C100 Architectural Common Component Design Escalator Tunnel Lighting Study

Document Number: C100-ATK-A-RST-CRG02-50002

Purpose of this Report

Original C100 design intent

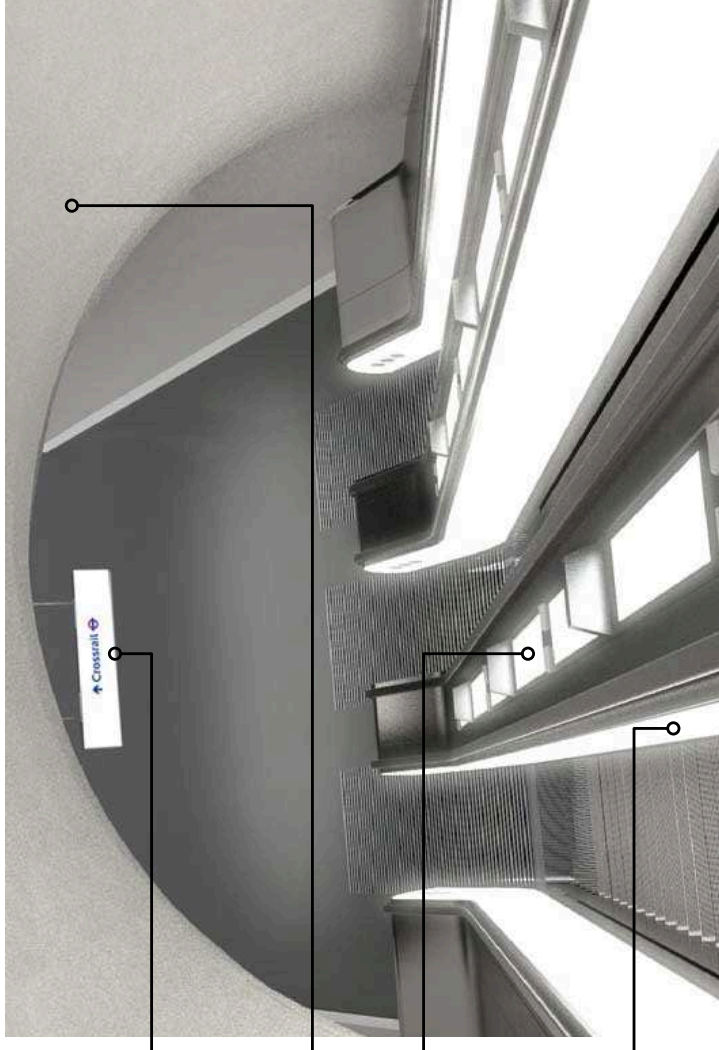
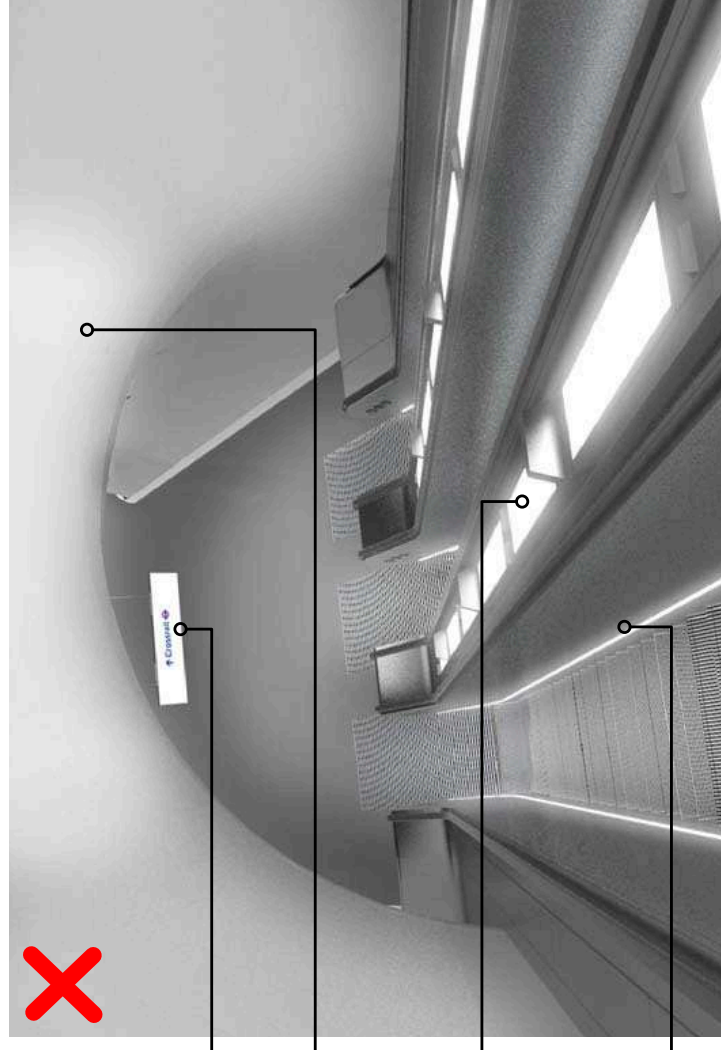
This change in form factor has an impact of the balance of the lit environment. The significantly reduced area of luminous balustrade surface is no longer complemented by the uniform luminance of the current SPL-502 escalator deck upright proposal.

SPL-502 dominates visually. Vault and balustrades appear dark in contrast. Unbalanced lit environment must be addressed to restore positive user experience

Otis skirting lighting proposal comprises continuous linear profile in low level skirting

To restore visual balance to the escalator environment, it is proposed that the lit appearance of SPL-502 is revised.

The purpose of this report is to establish an appropriate new optical configuration for the SPL-502 which:

- achieves the proposed lit effect;
- conceals light sources from view at sight lines typically arising from escalator/concourse use;
- maintains low-glare performance to ensure visual comfort of escalator users.

Proposed SPL-502 redesign

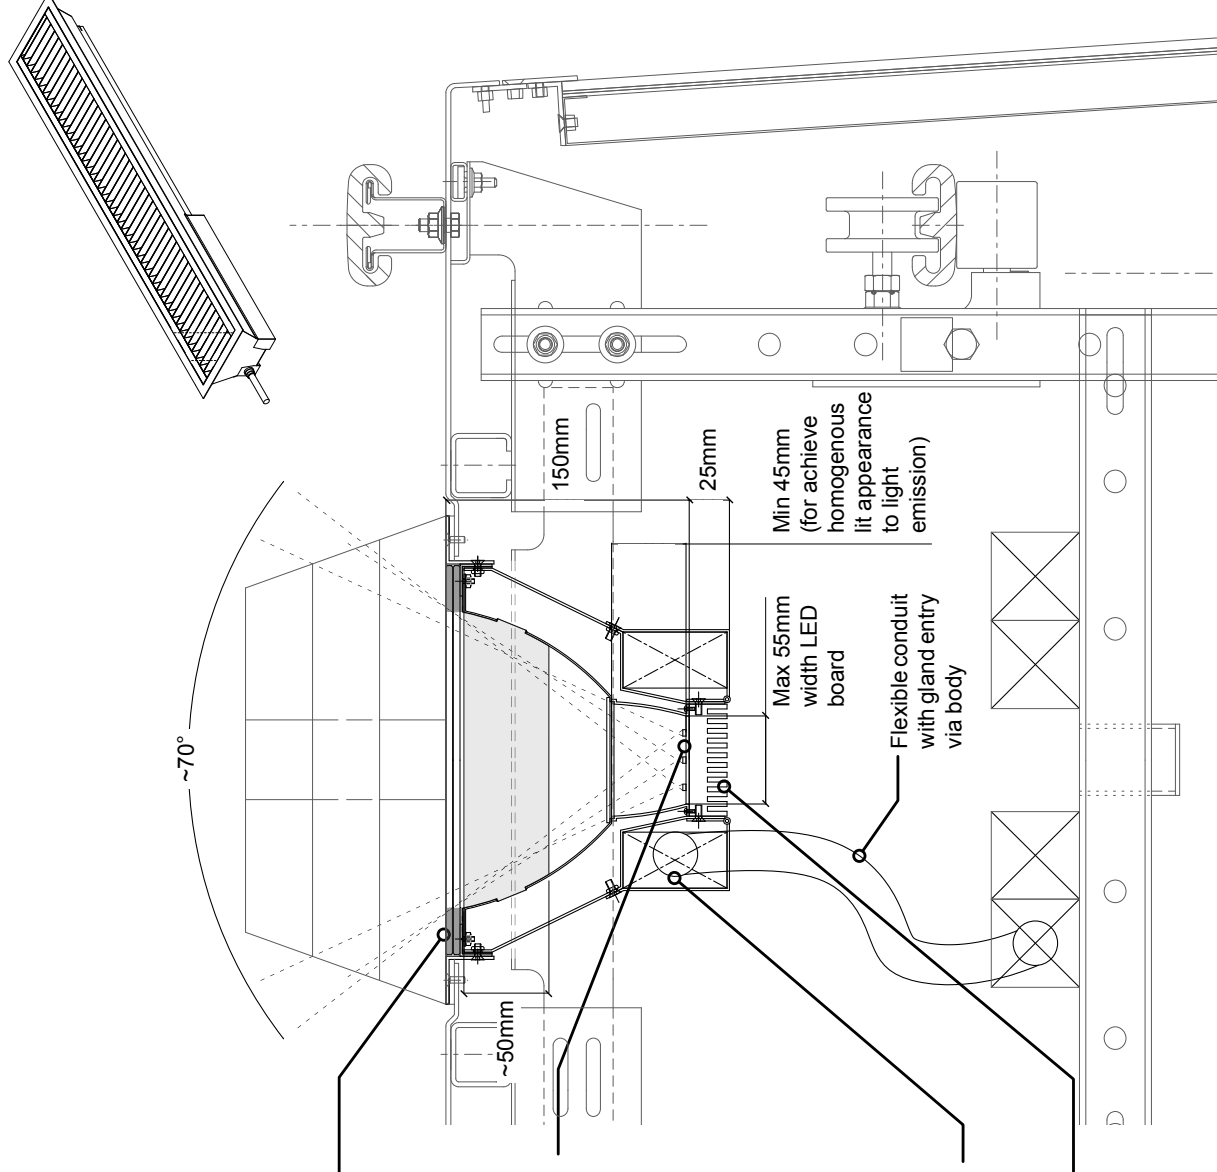
Linear LED light engine set beneath a sealed optical arrangement comprising:

- a primary reflector (specular) with high-efficiency diffuse / beam-shaping cover with homogenous uniformly luminous lit appearance when viewed transversely by escalator users;
- a secondary reflector with black anodised baffles (25mm centres);
- a clear laminated safety glass cover with black back-painted perimeter with potential for graduated black line/dot fritting if necessary to soften beam edge on vault soffit.

Secondary optic comprising:

- bead-blasted aluminium cross-blade louvres with black anodised finish - max thickness 1.5mm, spacing 25mm (pending testing)
- bead-blasted aluminium trough reflector with black anodised finish
- 2-ply glass laminate cover with black back-painted glass perimeter terminating flush with trough reflector (+ graduated black dot/line fritted pattern for softened beam edge)

Primary optic comprising linear LED board in high-efficiency white reflector (>97% reflectance) with 2-ply glass laminate cover housing PET micro-lens film to achieve:

- ~70° beam-shaping
- LED chip concealment
- L0° peak intensity gain
- L65° glare suppression

1. Where we are now: Existing SPL-502 prototype with low-luminance diffuser

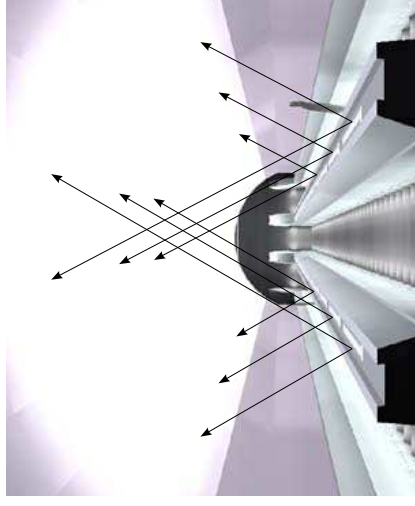
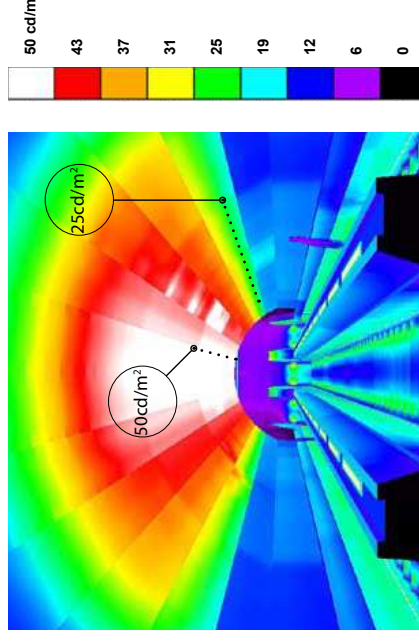
- Achieves $>50\text{cd/m}^2$ at the vault centre directly overhead and a broad distribution trailing off gradually to the sides
- Lighting unbalanced - deck brightness high compared to balustrades and vault. SPL-502 deck uplight design should be revisited to achieve more balanced lighting conditions to escalator tunnel

2. Proposed Alternative Design: Simulation of proposed SPL-502 redesign with baffles

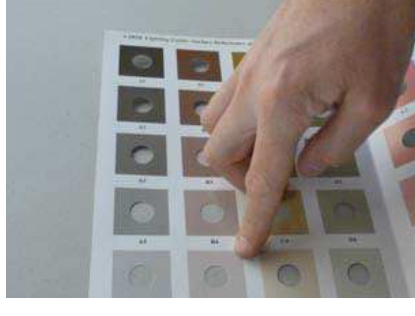
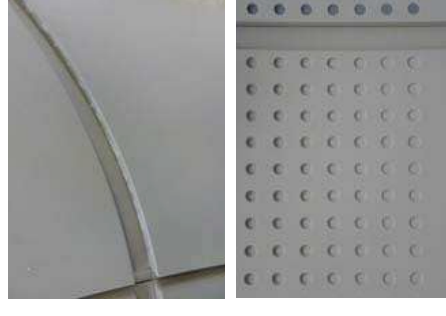
- + Revised optical assembly ensures luminaire is less easily recognised as light emitter
- + Lateral beam breadth only marginally reduced by cut-off angles essential for visual comfort
- + Diffuse effect achieved from direct source - new optical design maintains soft beam edge
- + $>50\text{cd/m}^2$ still achieved at the vault centre

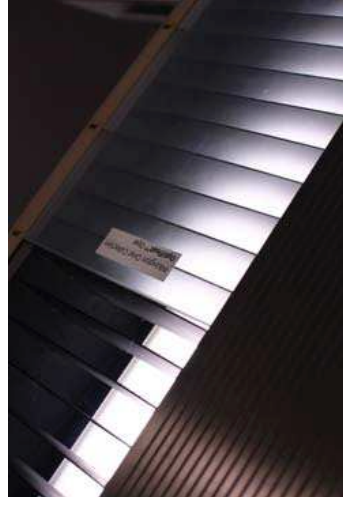
Lighter finish of secondary optic would reduce the perceived contrast between louvres and emitter and resultant patterning

Contrast between illuminated black louvre and diffuse light emitter - potential for photosensitive risk to be evaluated at prototype stage

Partially diffuse glass top cover would reduce contrast between louvres & light emitter, but surface luminance of SPL-502 increases contrary to design intent

- Comprehensive testing by the manufacturer is recommended at prototype stage. Should it be established that any risk is posed, only subtle optical modification to the proposed SPL-502 design would be necessary. A simple measure such as lightening the secondary optic finishes would reduce the perceived contrast between louvres and emitter and resultant patterning.

Application of a partially diffuse glass top cover (to reduce contrast between louvres & light emitter) would be another possible mitigation measure but is not preferred, as this would increase surface luminance of the SPL-502 and thereby increase contrast with escalator deck – opposing the objective of SPL-502 redesign to make the luminaire appear less prominent within the escalator tunnel.

Reducing spacing between louvres (to increase frequency of flashes per second) is not advised, as this measure would reduce the efficiency of the SPL-502 uplight and compromise the lighting conditions within the space.
